No. EC155-24-024

SERVICE BULLETIN

ELECTRICAL POWER - Radome

Check for interference between harnesses

Picture 1 - General overview "11DEL" Patchboard and "1PP33E" cable

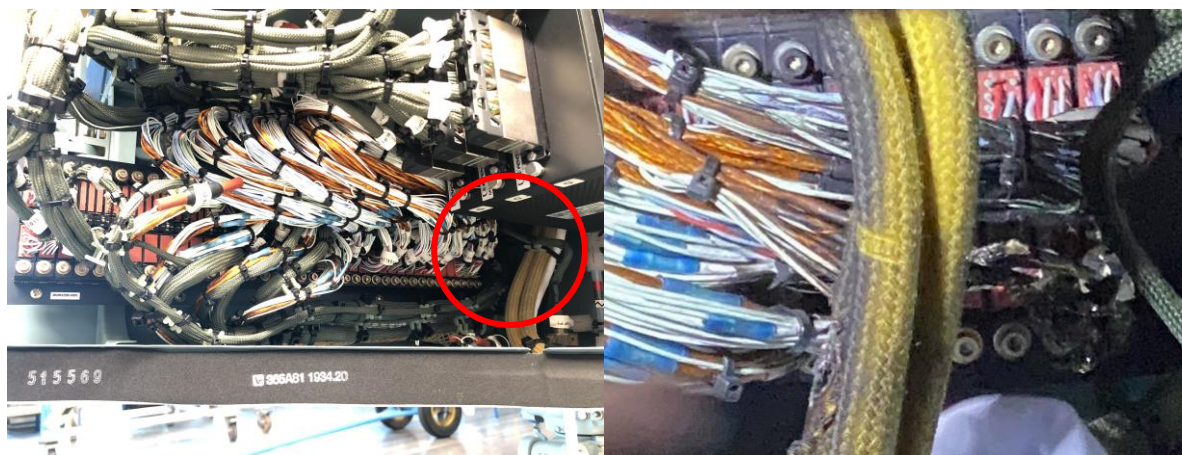
After investigation it was identified cable "1PP33E" damaged due to interference with harness "11D38-BP1". The FADEC was damaged as well.

The rest of the concerned customer fleet was inspected searching similar damage identifying two additional helicopters with marks in the same zone (see example in Picture 1 below).

Consequently, Airbus Helicopters recommends checking the cable routing and making sure that there is no damage on the harnesses located in the Radome.

Figure 1

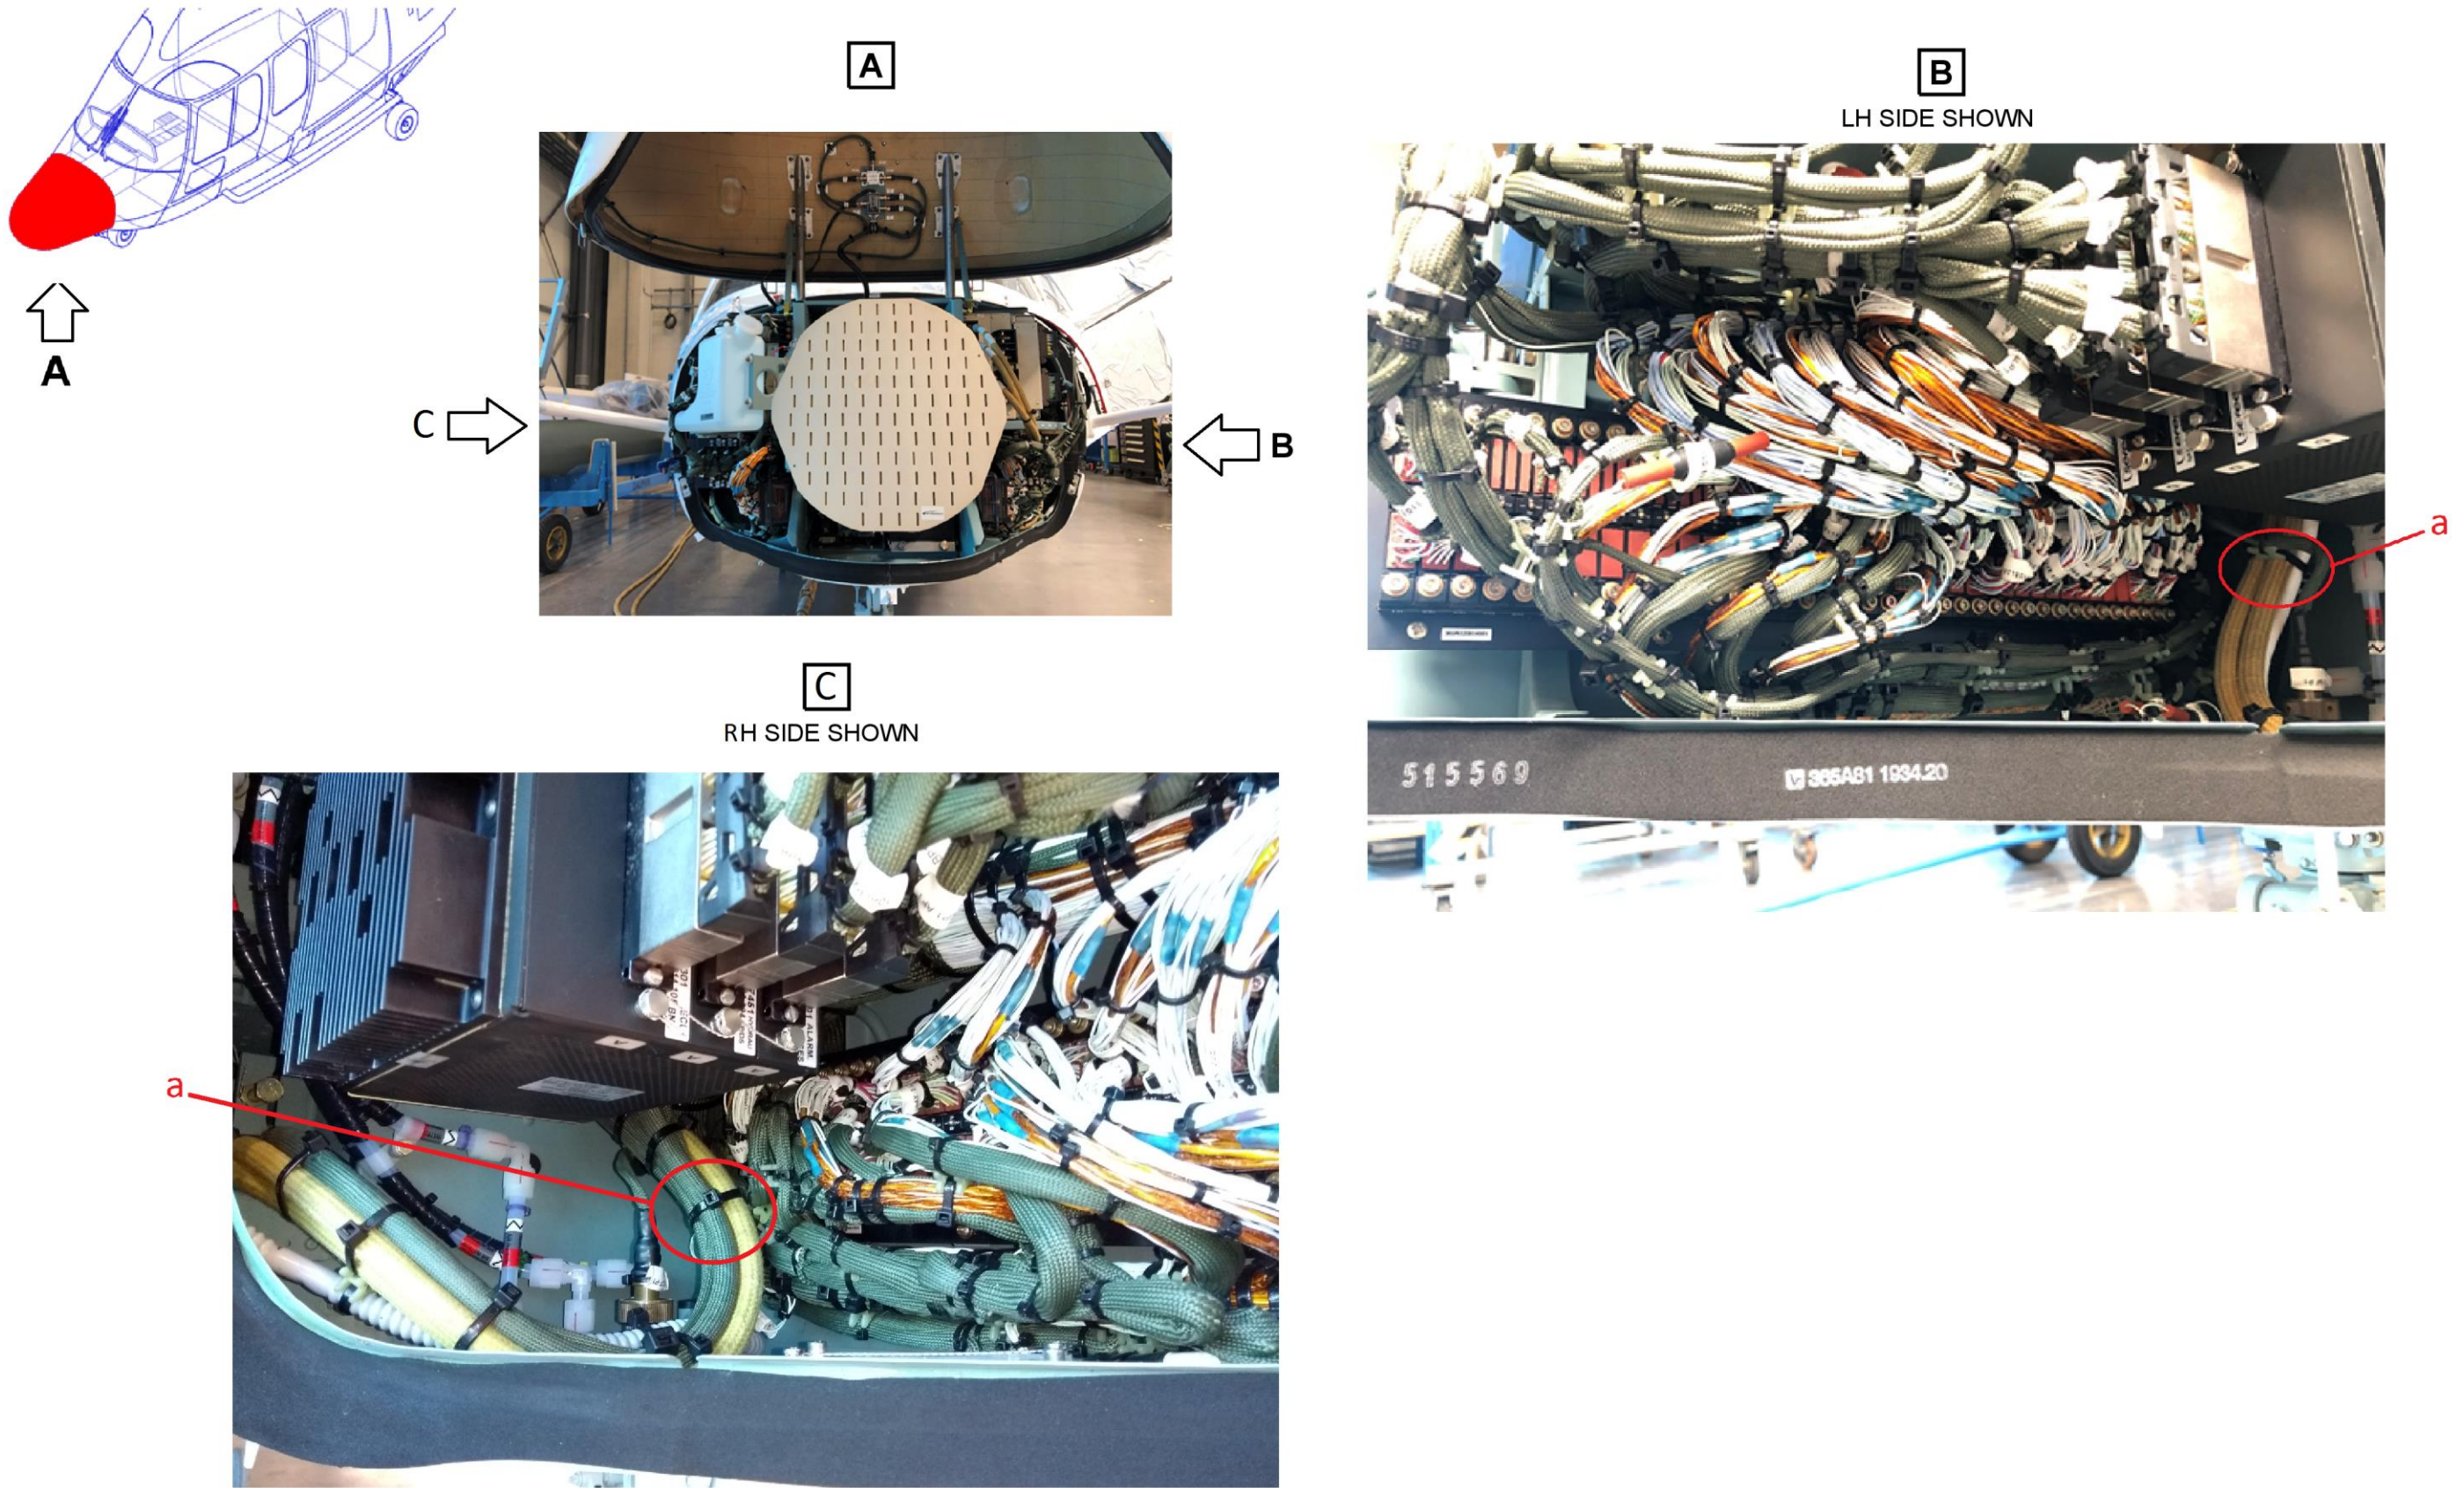
- Identify the cables with large cross-sections (a).
- Perform a visual check of the condition and routing of the cables with large cross-sections (a).
- Make sure that there is no interference between the cables with large cross-sections (a) and the surrounding components.

- If a cable is deteriorated:
 - . if only the sheath is deteriorated, repair the cable, refer to the Work Cards 20-80-20-103 (MTC) and 20-80-20-443 (MTC),
 - . if the sheath and the cable are deteriorated, before resuming flights, contact the Airbus Helicopters Support Department to get an approved repair solution by creating a Technical Event (TE) on WebTEK: <https://airbusworld.helicopters.airbus.com>
- Improve the cable routing: refer to Work Card 20-80-20-441 (MTC).
- If at least one cable is repaired and/or unplugged/plugged:
 - . comply with paragraph [3.B.3.](#)
